MWO 5-2350-262-35-1

MODIFICATION WORK ORDER

MODIFICATION OF ARMORED COMBAT EARTHMOVER (ACE), M9

SYSTEM IMPROVEMENT PLAN (SIP) PHASE 4 BLOCK MODIFICATION

Figure 2-1. Quick-Disconnect Reinstall at Air Compressor

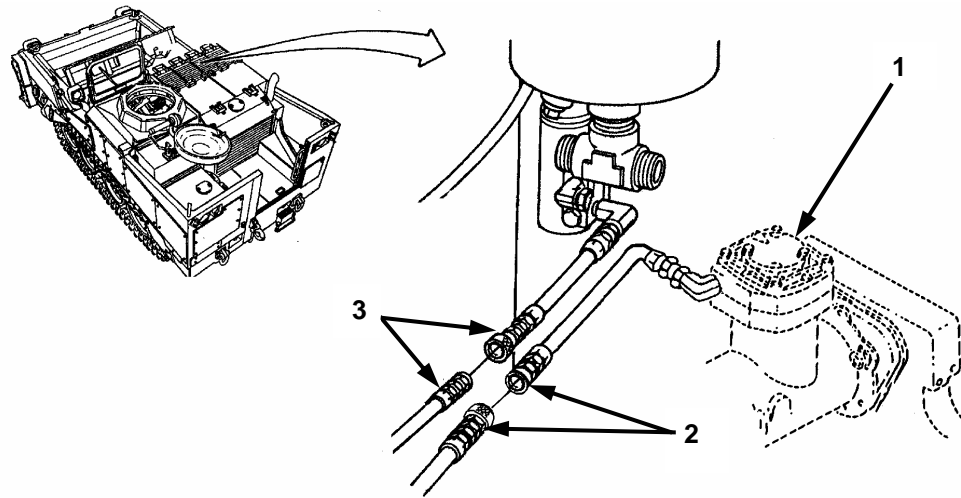
- b. Remove and reinstall quick-disconnect (2) on air compressor line with male coupling to air compressor (1). Verify quick-disconnect (3) on fuel return line has male coupling to fuel tank.

Figure 2-2. Quick-Disconnects and Guide Pin at Lower Rear Engine Bulkhead

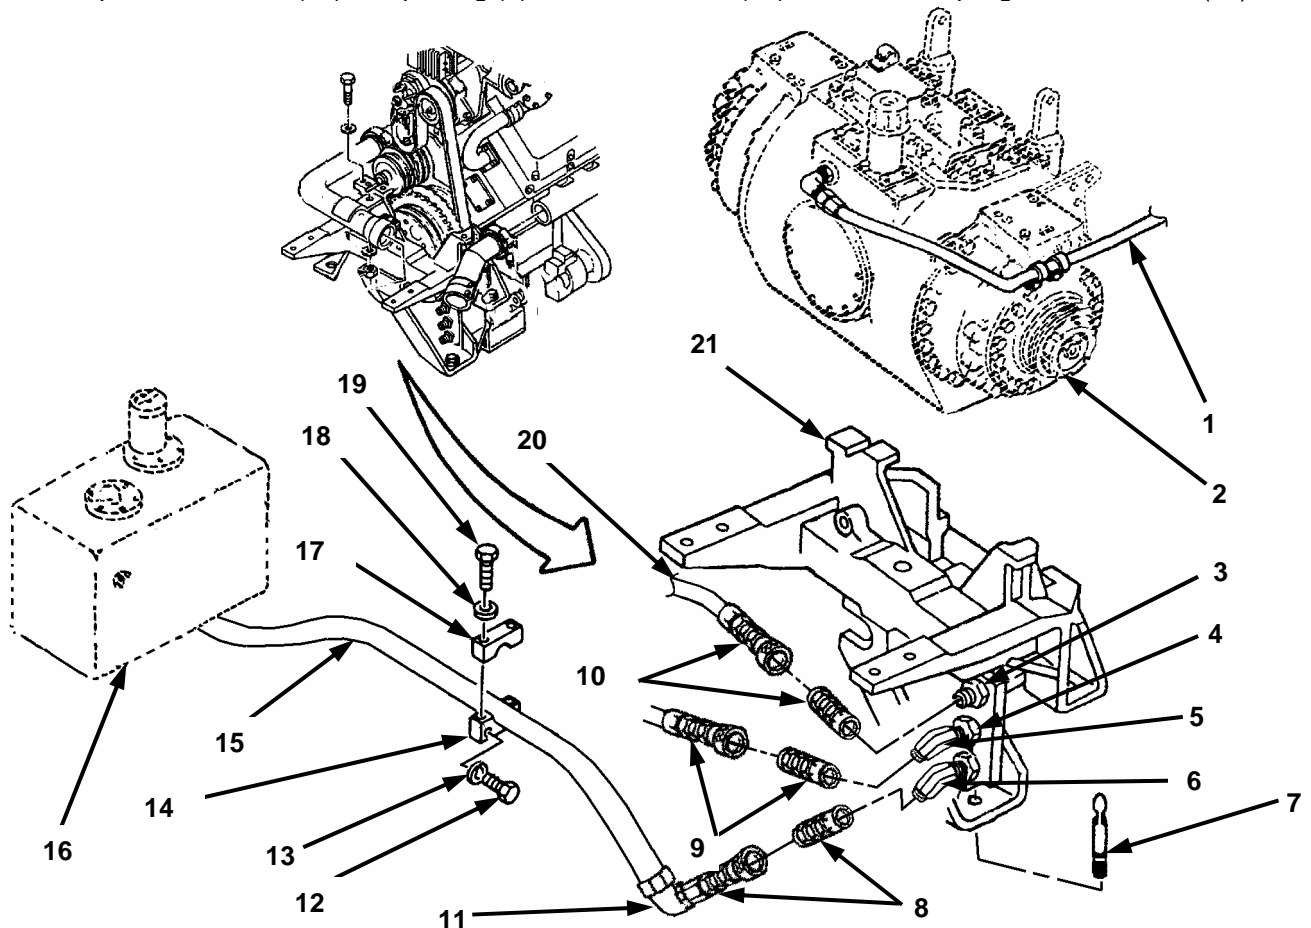
- d. On top fitting (3) of bracket (21), remove and discard hose (1) from rear of steer unit (2).
- e. Install quick-disconnect (10) at top fitting (3) and to new hose (20) with male coupling to bracket side (21).

- f. On middle fitting (4) of bracket (21), remove and discard 45° elbow MS51509A24 and install 35° elbow (5), facing down, on bracket.
- g. Install quick-disconnect (9) at middle fitting (4) on bracket (21) with male coupling to bracket side.
- h. Remove and discard two bolts (19), washers (18), and bracket (17) from bracket (14) on hull bottom plate.
- i. Remove and discard hose 13214E2551 and tube 12325766 from bottom fitting (6) of bracket (21) and hydraulic tank (16) bottom.
- j. Remove and discard bracket (14) from hull bottom plate, using method (1) or (2):
 - (1) Remove and discard two bolts (12), washers (13), and bracket (14) from hull bottom plate.

- (2) Using suitable aluminum cutting tool, cut and discard welded bracket (14) from hull.
 - (a) Grind raw area smooth on hull bottom plate using a suitable aluminum grinding tool.
 - (b) Clean, prime, and paint raw area using suitable CARC primer and finish paint per TB 43-0209.
- k. Install quick-disconnect (8) at bottom fitting (6) on bracket (21) with male coupling to bracket side.
- l. Install new 90° elbow (11) on one end of new hose (15).
- m. Install female quick-disconnect half (8) to 90° elbow (11).
- n. Route hose (15) on hull bottom in front of steer unit (2) and install hose end on bottom of hydraulic tank (16).
- o. Install guide pin (7) at lower rear engine mounting point.
- p. Install power package per TM 5-2350-262-34, Power Package Replacement–Installation, with following changes:

Figure 2-3. Compensating Pump between Hose and Elbow

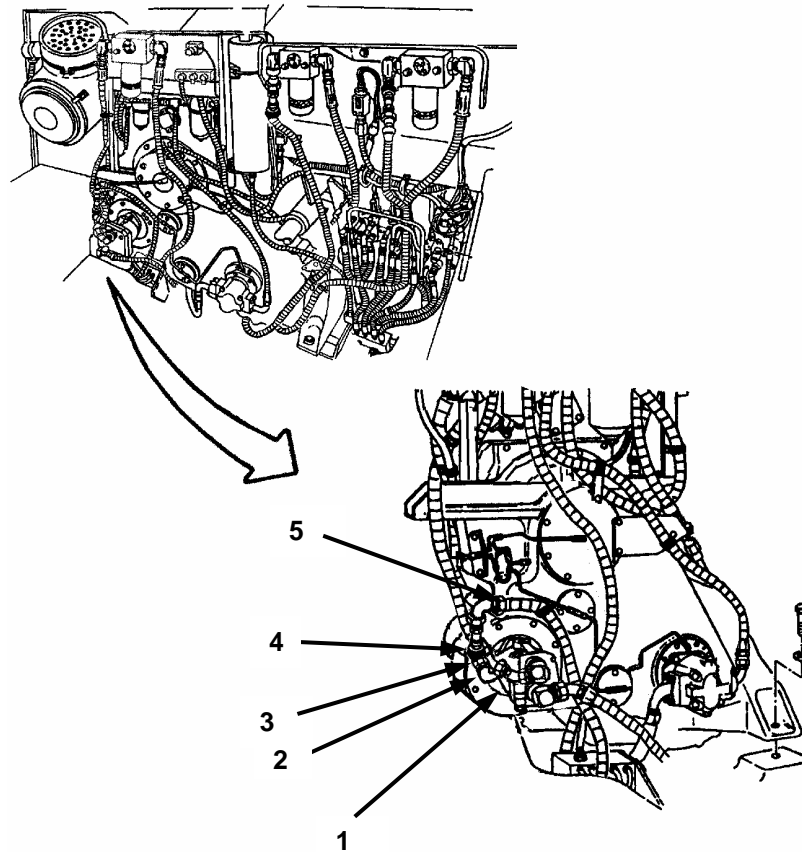
- (1) While performing TASK F per TM 5-2350-262-34, Power Package Replacement–Installation, adjust 90° elbow (2) on compensating pump to face up and angle towards transfer case.

- (2) Install quick-disconnect (3) on compensating pump at elbow (2) with male coupling to compensating pump.
- (3) Install new 90° elbow (4) to female half quick-disconnect coupling (3).
- (4) Reroute hose (5) up through front tubes on manifold, next to compensating pump, and above compensating pump to 90° elbow (4).

Figure 2-4. Hull Bottom Plate

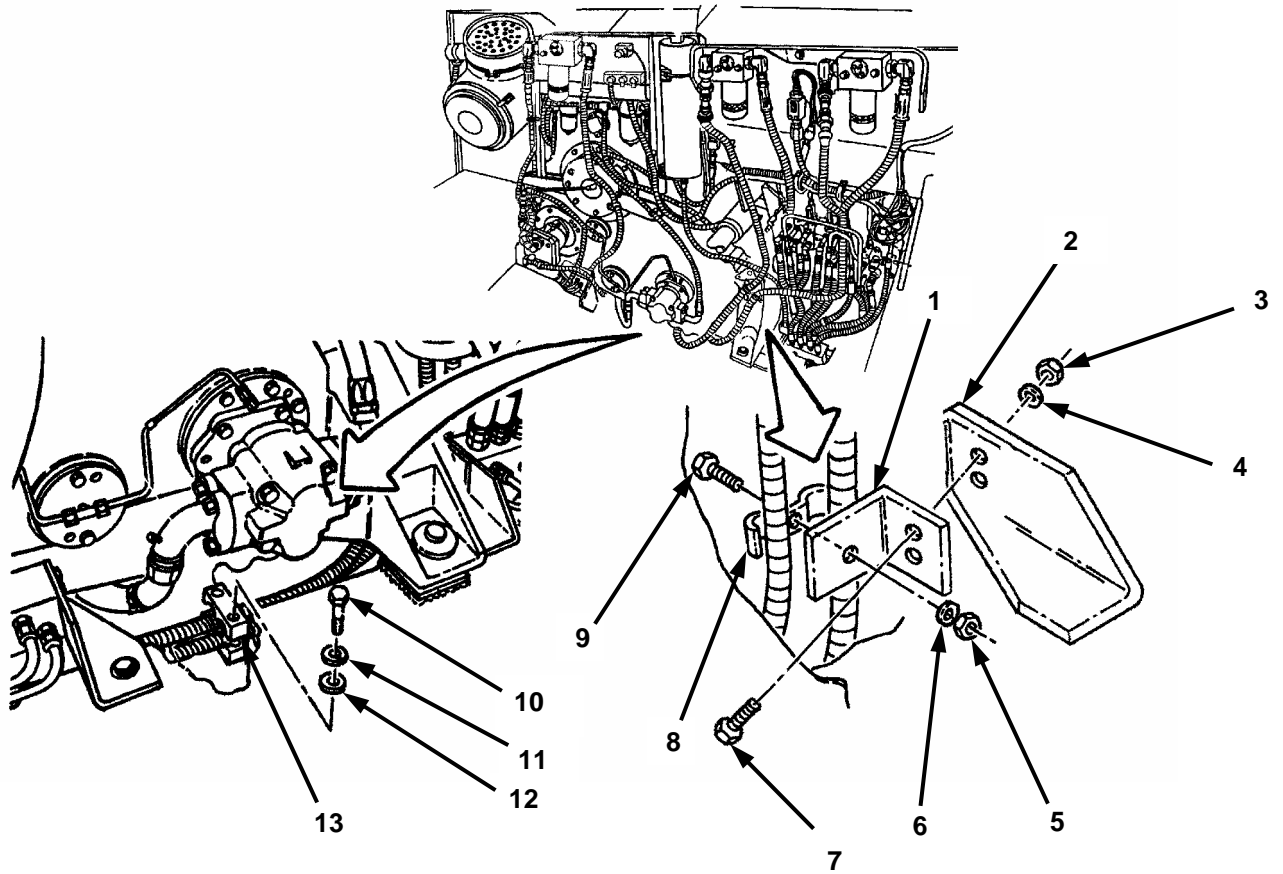
- (5) While performing TASK J and K per TM 5-2350-262-34, Power Package Replacement–Installation, perform the following steps:
- (a) Remove and discard cap screw (9), retaining strap (8), flat washer (6), and nut (5) from bracket (1).
- (b) Remove and discard two cap screws (7), flat washers (4), nuts (3), and bracket (1) from plate (2).
- (c) Remove and discard two machine bolts (10), retaining strap (13), flat washers (11), and nuts (12) from hull bottom plate.

Figure 2-5. High Pressure Filters

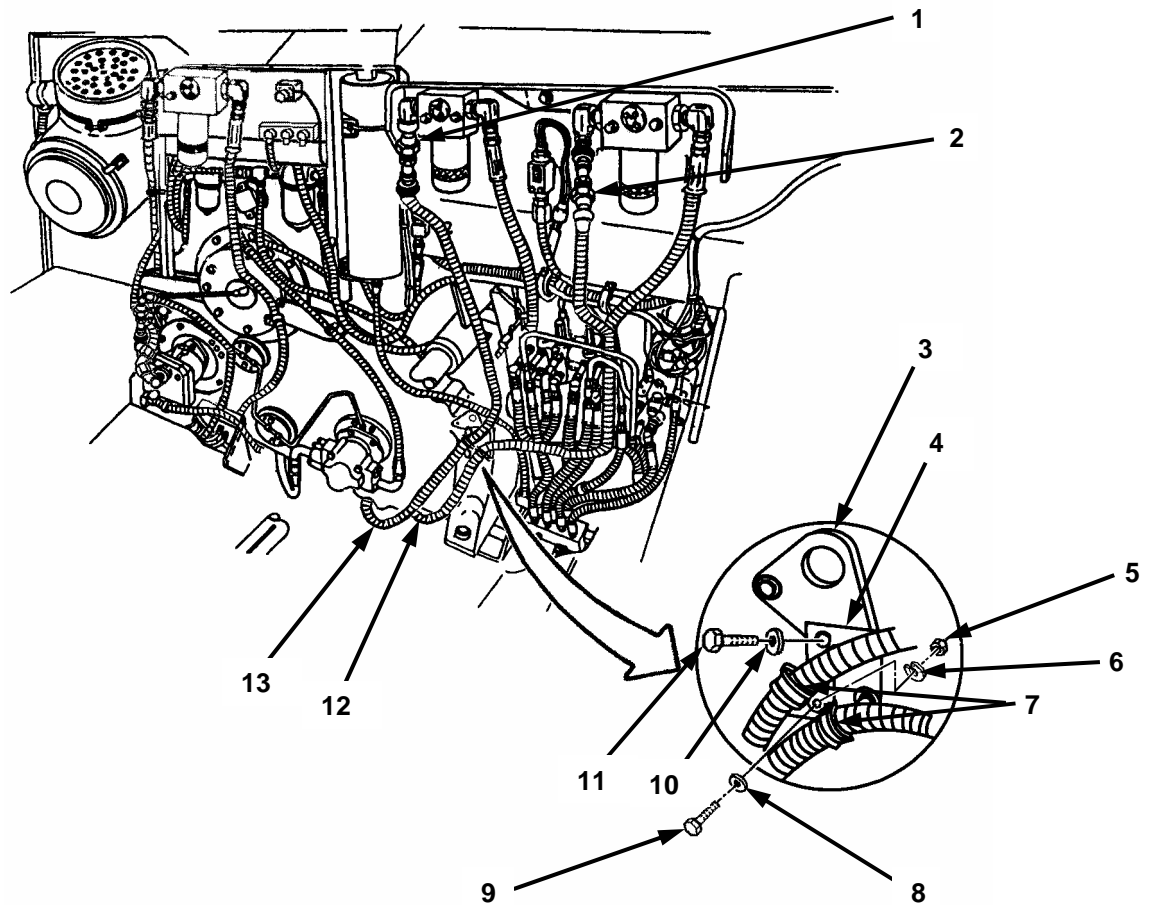
- (6) Reroute hoses (12 and 13) in front of engine transfer case, between scavenger pump and transfer case motor mount.

- (7) Install new bracket (4) to lifting eye (3) at bottom two bolt locations with existing two bolts (11) and washers (10).
- (8) Secure hoses (12 and 13) with clamps (7) to front of bracket (4) with screw (9), flat washer (8), lock washer (6), and nut (5).
- (9) Install quick-disconnect (1) at power package side high pressure filter with male coupling to high pressure filter.
- (10) Install quick-disconnect (2) at driver's compartment side high pressure filter with female coupling to high pressure filter.

Figure 2-6. Main Hydraulic Accumulator

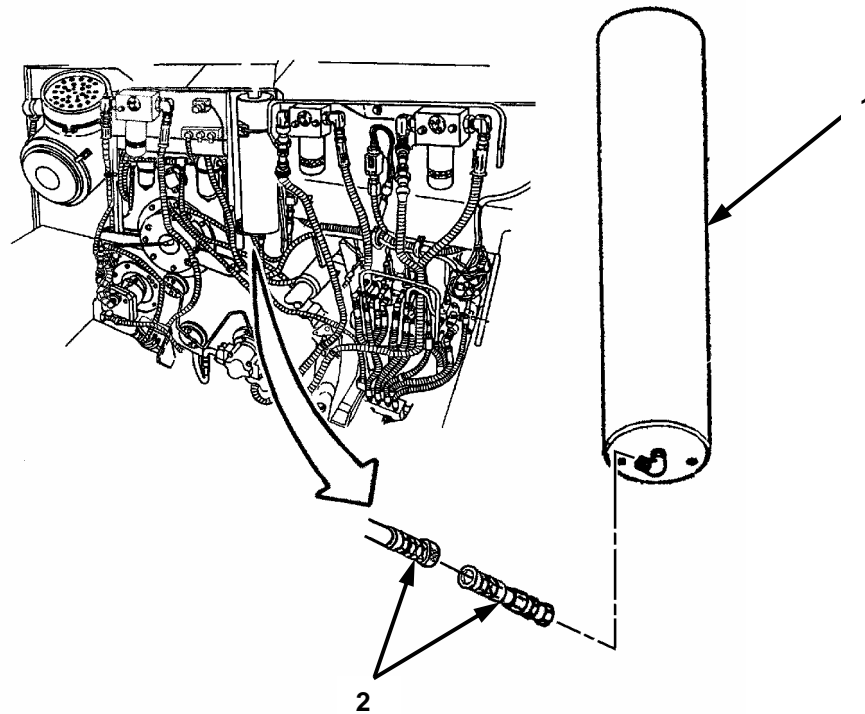
- (11) While performing FOLLOW-ON TASKS per TM 5-2350-262-34, Power Package Replacement-Installation, install quick-disconnect (2) at bottom of main hydraulic accumulator (1) with male coupling to main hydraulic accumulator.

Figure 2-7. Ejector Cylinder

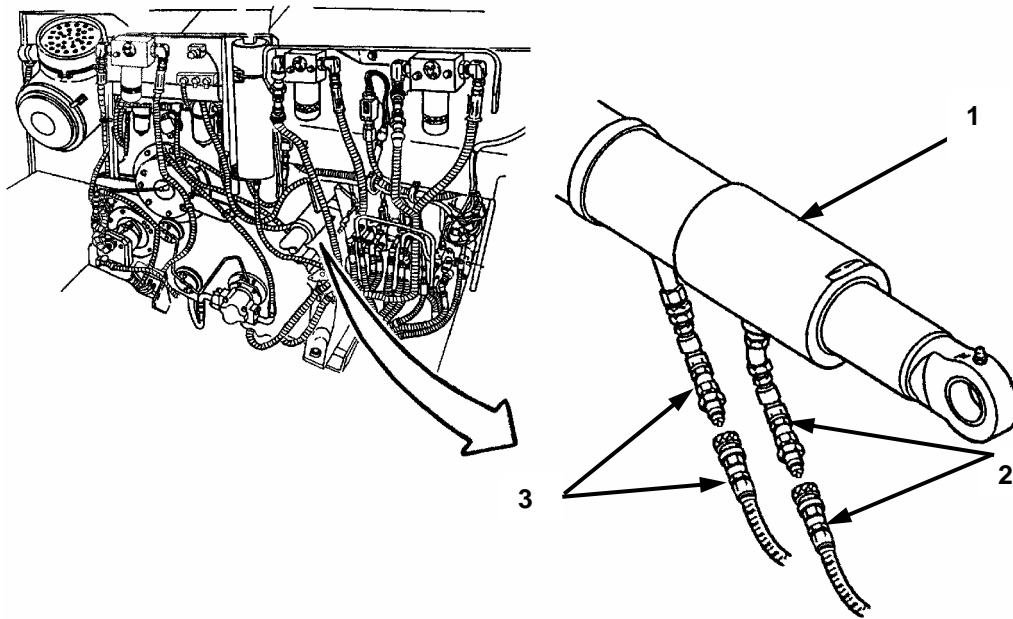
- (12) While performing FOLLOW-ON TASKS per TM 5-2350-262-34, Power Package Replacement–Installation, install two quick-disconnects (2 and 3) at ejector cylinder (1) with male couplings to ejector cylinder.

If ejector assembly is hitting the high pressure filter hose (1), refer to [M9 ACE News 'n' Views](#), June 2003, Volume 26 from within the Army Knowledge Online website, for recommended 45° elbow installation procedures.

Figure 3-1. Fire Extinguisher Bottle Holder Shield

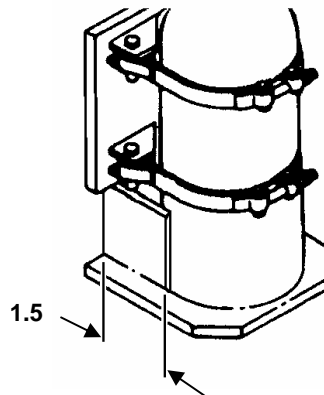
- d. Using suitable aluminum cutting tool, cut right side fire extinguisher bottle holder shield from holder, leaving 1.5 inches on each side (Figure 3-1).
- e. Using suitable aluminum grinder, smooth new edges and surfaces.

- f. Clean, prime, and paint raw area with suitable CARC prime and finish paint per TB 43-0209.

Figure 3-2. Left Side Nozzle Bracket Installation

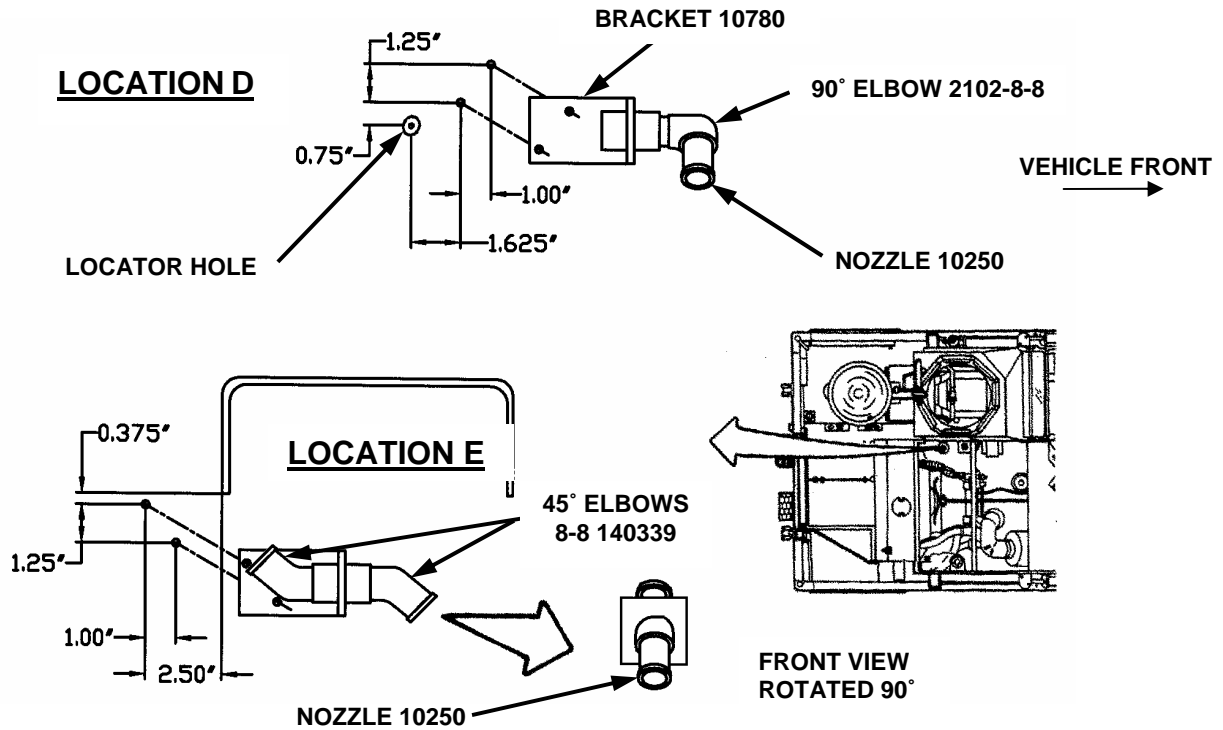
- a. Using suitable machinist's ruler, measure, mark, and center punch, for drilling and tapping four holes for two brackets (10780) on left side (Figure 3-2).
- b. Drill 4 x .25 x 20-UNC-2B holes .375 inch deep only and bottom end tap holes, ensuring maximum thread depth of .375 inch.
- c. Install two brackets (Figure 3-2) with four washers (MS27183-49) and screws (B1821BH025C050N).
- d. Install one 90° elbow (2102-8-8) and nozzle (10250) at LOCATION D (Figure 3-2). Using suitable machinist's protractor and straight edge, direct 90° elbow towards engine with 25° angle down from horizontal.

- e. Install two 45° elbows (8-8 140339) and one nozzle (10250) at LOCATION E (Figure 3-2).
- f. Direct forward 45° elbow at LOCATION E (Figure 3-2) towards vehicle front with 45° angle down. Direct rear 45° elbow at Location E (Figure 3-2) towards vehicle rear with 45° angle up.

Locator hole for Location D (Figure 3-2 above) is hole for fire extinguisher system cable into driver's compartment.

Figure 3-3. Left Side Installation

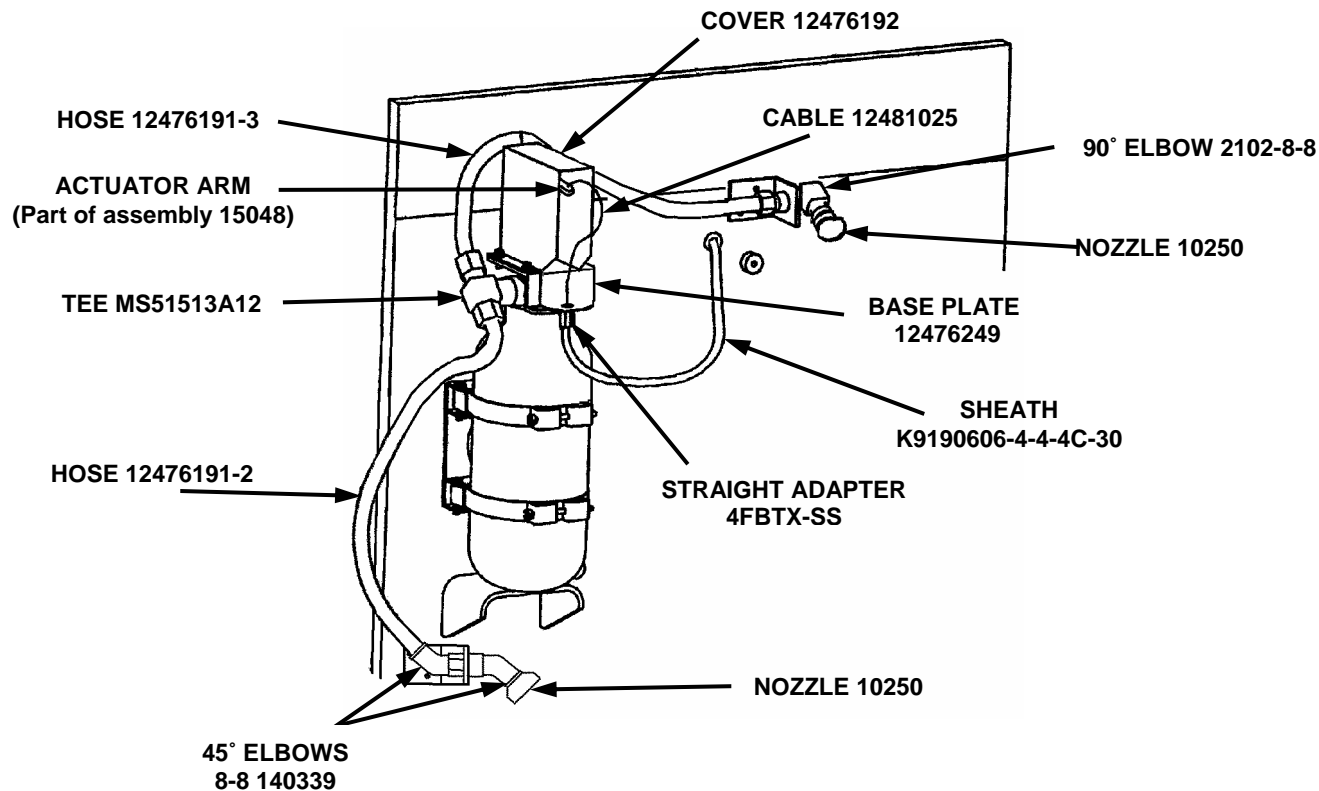
- g. Inside operator compartment, wire rope free play measurement should not exceed two inches (changed from four inches to two inches).
- h. Refer to Figure 3-3 below to verify placement of hoses and elbows.

Figure 3-4. Right Side Nozzle Bracket Installation

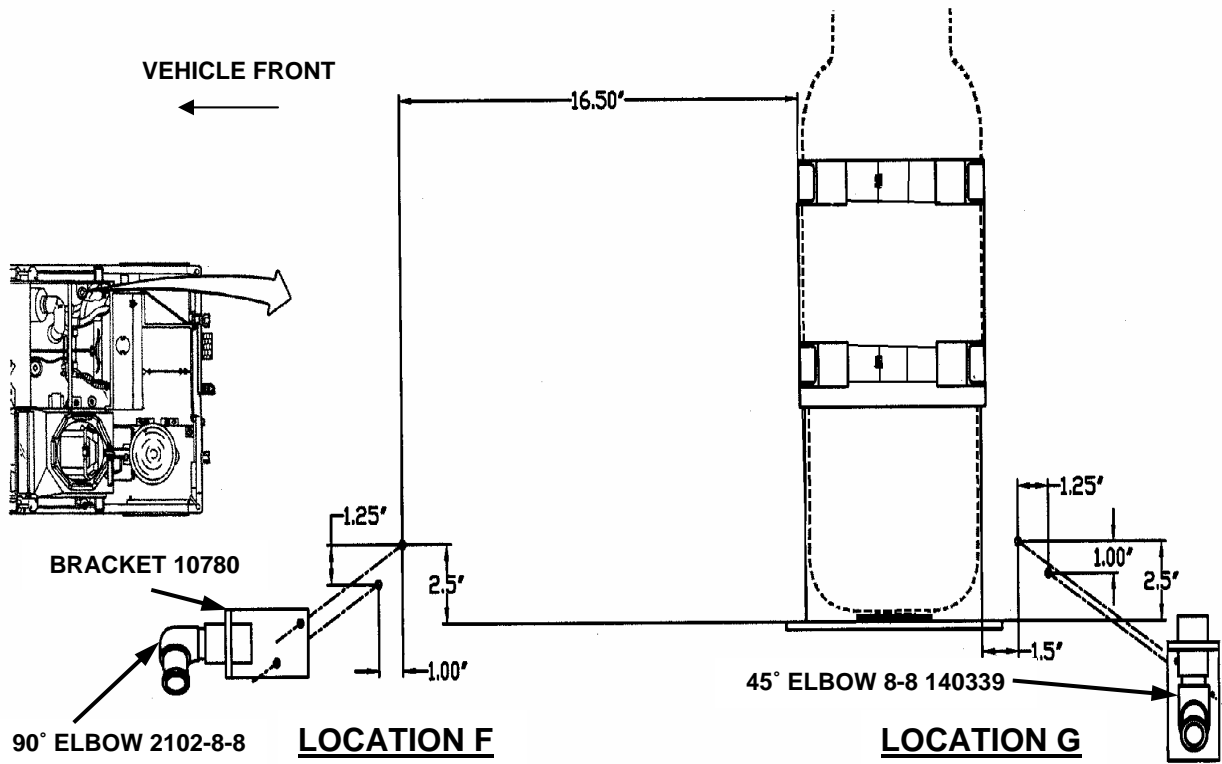
- Using suitable machinist's ruler, measure, mark, and center punch, for drilling and tapping four holes for two brackets (10780) on right side (Figure 3-4).
- Drill 4 x .25 x 20-UNC-2B holes .375 inch deep only and bottom end tap holes, ensuring maximum thread depth of .375 inch.
- Install two brackets (Figure 3-4) with four washers (MS27183-49) and screws (B1821BH025C050N).
- Install 90° elbow (2102-8-8) and nozzle (10250) at LOCATION F (Figure 3-4). Using suitable machinist's protractor and straight edge, direct 90° elbow towards engine at 10° down from horizontal.
- Install 45° elbow (8-8 140339) and nozzle at (10250) LOCATION G (Figure 3-4). Direct 45° elbow directly towards left side of vehicle.
